UNITED STATES
DEPARTMENT OF THE INTERIOR
BUREAU OF LAND MANAGEMENTFORM APPROVED
OMB NO. 1004-0137
Expires: January 31, 2018**SUNDRY NOTICES AND REPORTS ON WELLS**
*Do not use this form for proposals to drill or to re-enter an abandoned well. Use form 3160-3 (APD) for such proposals.***SUBMIT IN TRIPLICATE - Other instructions on page 2**

East Blinebry Drinkard Unit (EBDU) #43

API No. 30-025-06573

**Apache Corporation
East Blinebry Drinkard Unit 43
API 3002506573
May 24, 2018**

BLM Proposed

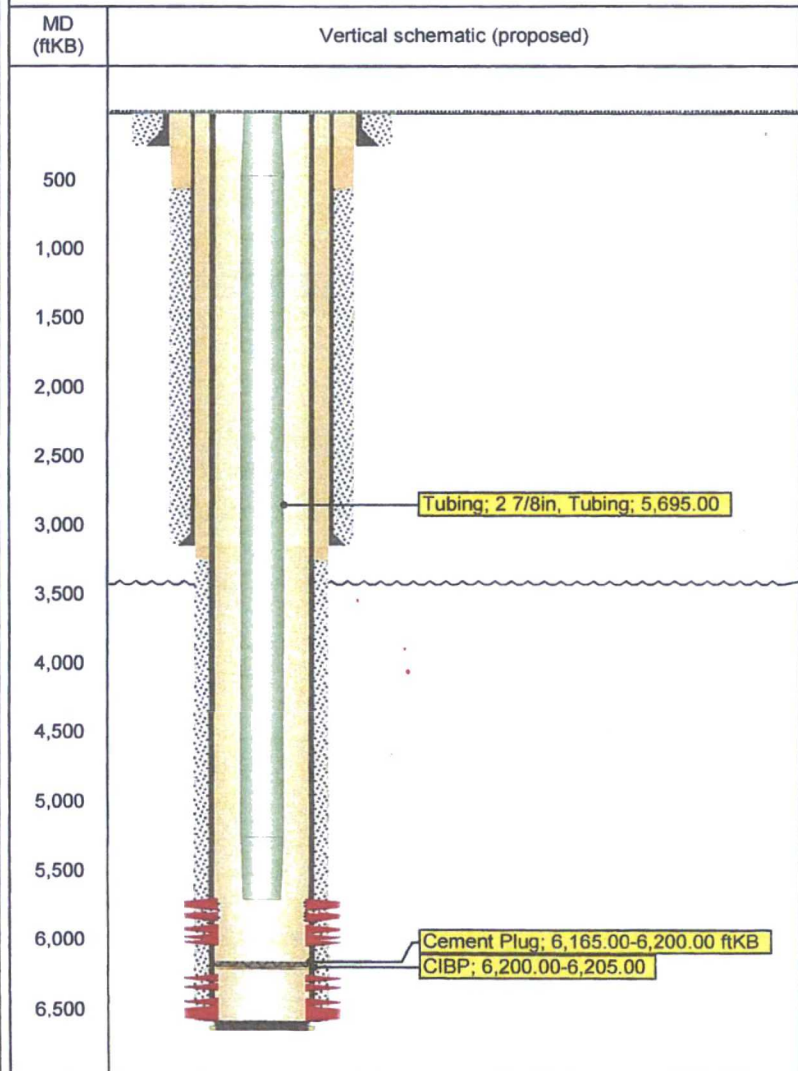
Remedial work needs to be performed on either the 9 5/8" or 7" casing in order to get cement to surface or tie-back a minimum of 200' into the previous casing
